Mona Change Request Report

Version	Purpose of document	Authored by	Reviewed by	Approved by	Review date
F01	Change Request	Burges Salmon LLP	Mona Offshore Wind Ltd	Mona Offshore Wind Ltd	1 Nov 2024
F02	Change Request Update	Burges Salmon LLP	Mona Offshore Wind Ltd	Mona Offshore Wind Ltd	15 Nov 2024
Prepared	by:	Prepar	ed for:

Document Reference: S_CR_ 2

Extract from Works Plans – Onshore (AS-003)

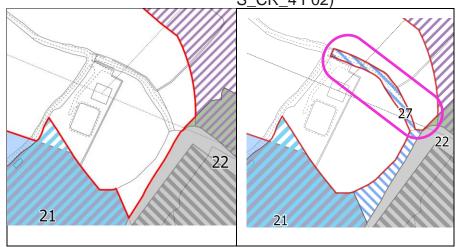
Change 1a – Order Limits change to include an existing access track to the west of the onshore substation for temporary access during onshore site preparation works

- 1.2.1.2 This change will result in the inclusion of a section of the existing access track at the onshore substation at grid reference SJ 01353 73277 within the Order Limits to accommodate temporary access.

- 1.2.1.3 This existing access track is currently being utilised by the Applicant for ongoing site survey and investigation works. This change does not involve any works or upgrades to the existing track, the track will only be used to take access to Work Nos. 21, 22 and 33 (and other works areas through Work Nos. 21, 22 and 33).

- 1.2.1.4 As shown on the Change Request: Works Plan Onshore (Document Reference S_CR_4 F02), Change 1a will become part of Work No. 27.
- 1.2.1.5 Change 1a delivers an access to the onshore substation site area for onshore site preparation works period only. Use of this access will allow time-critical, and in some cases seasonally restricted, onshore site preparation works to be undertaken at the onshore substation site before the temporary construction

Extract from Works Plans – Onshore (AS-003)

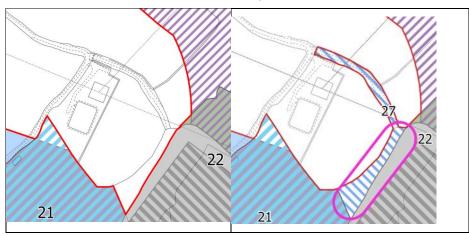
Change 1b – Order Limits change to include an area to the west of the proposed onshore substation for temporary access during onshore site preparation works and construction of the onshore substation and surrounding works

- 1.2.1.7 Change 1b results in an extension of the Order Limits from Work No. 22 to the field boundary where the existing access track (subject of Change 1a) terminates at grid reference SJ 01384 73165 for:

- temporary access during onshore site preparation works where access from the local highway network will be taken through the land included in Change 1a; and

- temporary access during construction to provide an additional means of access around the north-western corner of the onshore substation, taken from other Works areas around the onshore substation site. During this construction period, access to Change 1b will be from the construction access from Glascoed Road (via intervening Work areas).

- 1.2.1.8 As shown on the Change Request: Works Plan Onshore (Document Reference S_CR_4 F02), Change 1b will become part of Work No. 27.
- 1.2.1.9 The additional areas of land required for Changes 1a and 1b amounts to approximately 2611m². Whilst this land was included within the Mona PEIR Offshore Wind Project Boundary published in April 2023, it was removed prior to submission of the Application in an effort to reduce overall land take. However, as part of the ongoing early design work, it has become clear that use of this existing access track and associated land is necessary to facilitate onshore site preparation works at the substation site and to ensure these works can be delivered in a timely manner. In particular Change 1b delivers two needs for the project:

Extract from Works Plans – Onshore (AS-003)

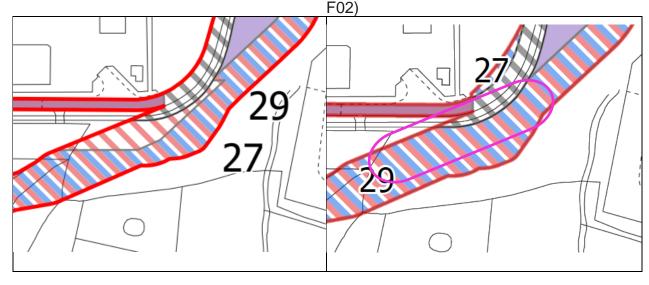
Change 2b – Amendment to Work No. 27 to widen the temporary onshore substation construction access road at grid reference SJ 01906 735519 by including a small area of additional land to the area identified for Work No. 27 (approximately 538m²) within the existing Order Limits. This land is currently identified as part of the permanent onshore substation access (Work No. 29) only.

- 1.2.2.4 The Applicant's preliminary design work has identified additional space is needed along the temporary construction access road in this area to facilitate the AIL's whilst ensuring adequate space for the fencing requirements outlined in the Outline Fencing Management Plan (REP2-048).
- 1.2.3 Change 3 Amendment of the proposed Order Limits to include additional land adjacent to the onshore substation construction access bellmouth to accommodate a temporary construction drainage attenuation basin

Extract from Works Plans – Onshore (AS-003) Extract from Change Request: Works Plan - Onshore (Document Reference S_CR_4 F02)

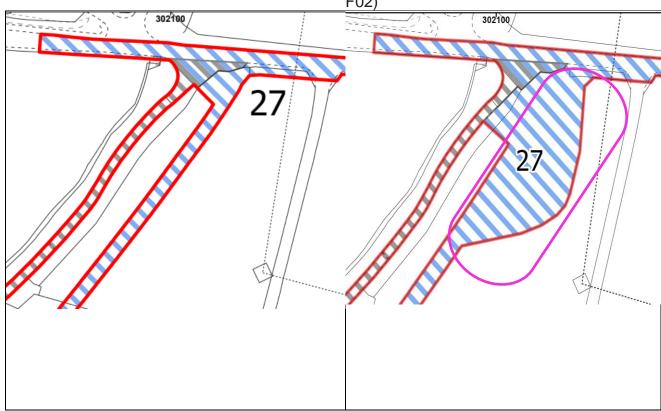
- 1.2.3.1 This change results in a widened temporary onshore substation construction access road (eastward) to accommodate an additional temporary Sustainable Urban Drainage System (SuDS) attenuation pond at the northern extent of the onshore substation construction access road.

- 1.2.3.2 The additional area of land required for Change 3 amounts to approximately 2350m². Whilst this land was included within the Mona PEIR Offshore Wind Project Boundary published in April 2023, it was not included upon submission on the basis of the preliminary designs for the onshore substation construction access road. However, the Applicant's early detailed design works for the onshore substation construction access road, including the swept path analysis outlined in Change 2 (specifically Change 2a), have identified the need for additional land take. This is in order to deliver attenuation to control the discharge of surface water during construction, in part due to the wider road outlined in Change 2a, and also from the requirement for great crested newt fencing to be deployed, likely resulting in additional drainage pathways. It is proposed to construct a temporary SuDS attenuation basin as a measure to control this additional surface water runoff. The proposed Change 3 will result in

a controlled surface water discharge into an existing drainage channel, reducing the risk of increased flooding downstream.

Extract from Works Plans – OnshoreExtract from Change Request: Works Plan (AS-003) - Onshore (Document Reference S_CR_4

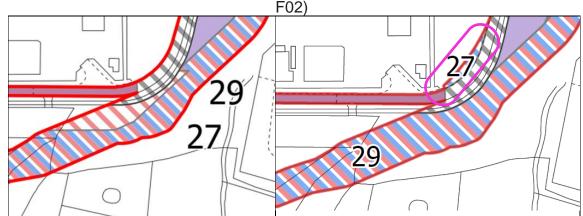
- 1.2.4 Change 4 Amendment and widening of the proposed Order Limits to include an area of land to accommodate an area of hardstanding during the construction period to allow establishment of the permanent access road
- 1.2.4.1 This change results in an extension of the Order Limits at grid reference SJ 01935 73551 to include the site of proposed Change 4. Proposed Change 4 will comprise a temporary area of hardstanding to be constructed immediately to the north of the existing road providing access to Bodelwyddan National Grid Substation and Gwynt y Mor Offshore Transmission Operator substation. This hardstanding will be in place during the construction period only and is necessary to facilitate the establishment of the permanent access road (Work No. 29).

- 1.2.4.2 In providing this temporary hardstanding, disruption to the users of the existing road will be reduced by removing the need to temporarily close the road for construction purposes.

- 1.2.4.3 The additional area of land required for Change 4 amounts to approximately 126m². Whilst the land required for proposed Change 4 was included within the Mona PEIR Offshore Wind Project Boundary published in April 2023, it was not included upon submission on the basis of the preliminary designs for the onshore substation area. As with the other changes set out above, the need for the extension to the Order Limits at this location has subsequently arisen as a result of the Applicant's early detailed design works and as a consequence of ongoing landowner engagement. The landowner has expressed a preference to implement the permanent access road at the furthest possible point along the alignment of the existing access road and this change is necessary to facilitate that option. For the avoidance of doubt, despite this proposed Change 4, the Applicant needs to retain the access route optionality in this area (as shown on sheet 11 of Works Plans - Onshore (AS-003)) due to the complex nature of the constraints within these areas – utilities (including a high pressure gas main), drainage infrastructure, export cables, desire for continuity of access over the existing road, amongst others. The preferred option will be selected during the detailed design process.
